# s310\_nrf51422 migration document

## S310\_nrf51422\_2.0.0

This section describes how to migrate to s310\_nrf51422\_2.0.0 from s310\_nrf51422\_1.0.0.

#### Transmission from continuous scanning device now supports wild card ID parameters

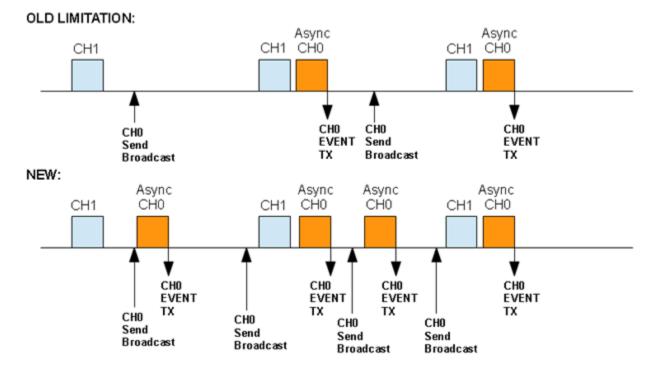
In order to allow continuous scanning devices to respond to incoming messages that matches one or more of the scanning channel ID fields, wildcard parameters ("0" value field in Device Number, Device Type and/or Transaction Type) can be specified when configuring the ID of the channel used for generating the response.

By using wildcard ID fields in this manner, the overall response latency can be reduced for situations where the continuous scanning device needs to reply immediately to incoming messages sent by multiple devices with different IDs.

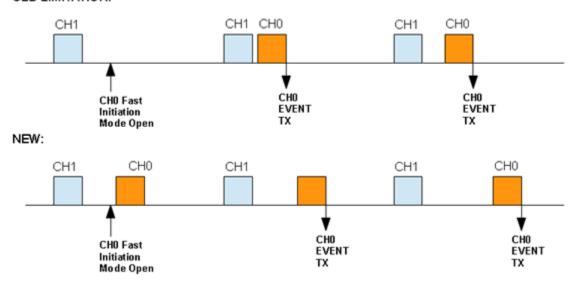
In S310 v1.0.0, when sending a transmission via a channel configured with the EXT\_PARAM\_ASYNC\_TX\_MODE extended channel type in the presence of other running ANT channels, the transmission would not occur until after the next scheduled ANT activity has run.

This limitation has now been removed. Asynchronous transmissions, in the presence of other running channels, are now performed immediately unless it is blocked by a previously scheduled radio activity. See the figure below.

In S310 v1.0.0, when opening a channel configured with the EXT\_PARAM\_FAST\_INITATION\_MODE extended channel type in the presence of other running ANT channels, the channel would not start until after the next scheduled ANT activity has run.

This limitation has now been removed. Channels configured with fast channel initiation will now start immediately, unless it is blocked by a previously scheduled radio activity. See the figure below.
